City of Portland, Maine - Building or Use Permit Application

Permit No: 06-1115	Issue Date:	CBL: 125 H005001
-----------------------	-------------	---------------------

Project: McAdam/McGowan residence

MINOR SITE PLAN
EXISTING CONDITIONS
25 COTTAGE STREET, PORTLAND, MAINE
THOMAS J. MCADAM

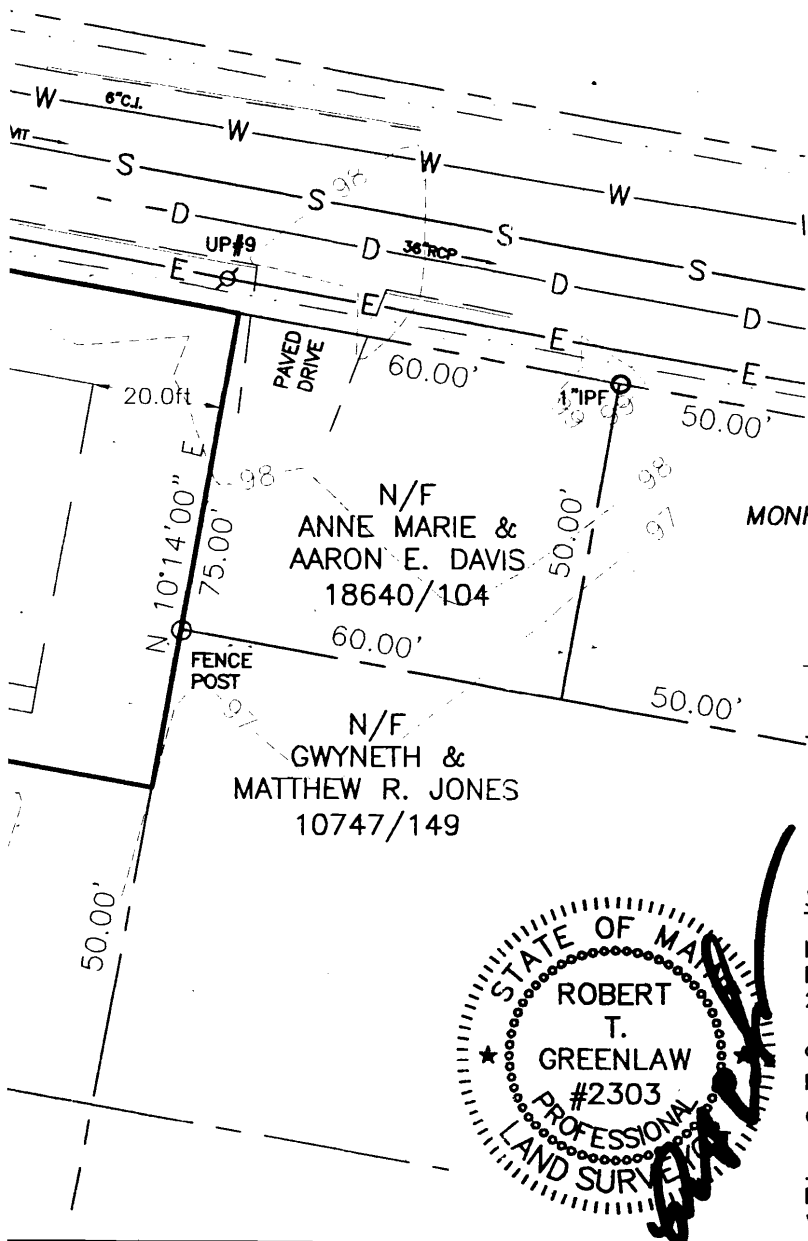
Garage to be built at later date
 T. Greenlaw
 8-17-06

MINOR SITE PLAN
 PROPOSED NEW DWELLING
 25 COTTAGE STREET, PORTLAND, MAINE
 FOR: THOMAS J. MCADAM

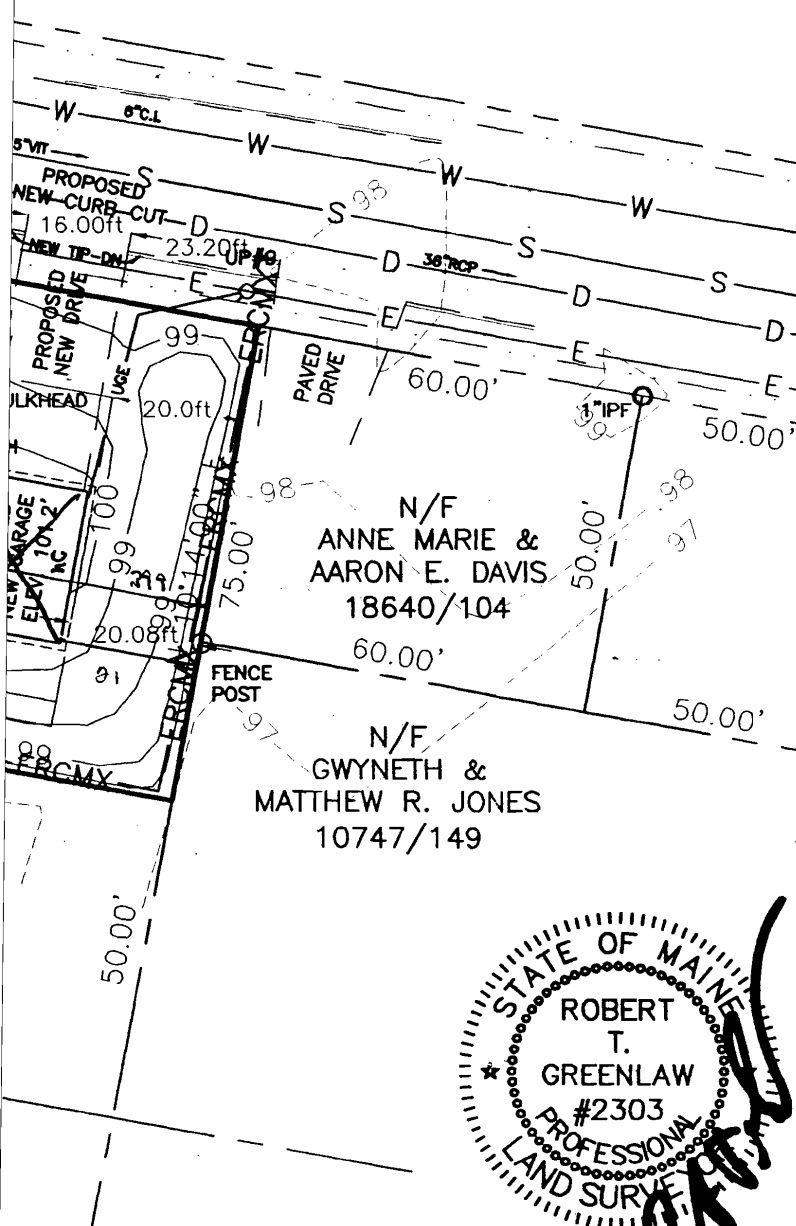
08/15/2006-amachado: Spoke to Jolene. The footprint of the house on the site plan and the blue prints does not match up. She was going to call her architect and have the architect call me.

The site plan does not match the building plans. Glenn Harmon said that the building plans are correct so the site plan must match the building plans.

1. The foundation on the left side of the building (facing Ashmont Street) on the building plan extends 30.5' from the backside towards the front. Then it indents 6.5 ' towards the right side and then extends 5.5' towards the front. The foundation on the site plan needs to match this.
2. The position of the bay window on the front of the house needs to match the building plan.
3. The bulkhead needs to be taken off of the site plan.
4. The steps that come off of the entry porch on the left side of the building must go towards Ashmont Street.
5. If the garage is not part of this permit then the footprint of it must be taken off of the site plan and the house plans.

08/16/2006-amachado: Spoke to architect Glen Harmon. He will get the site plan updated to match the building plans. He said that the garage is not being built at this point.

08/17/2006-amachado: Tom McAdam came in and made the changes on the site plan.
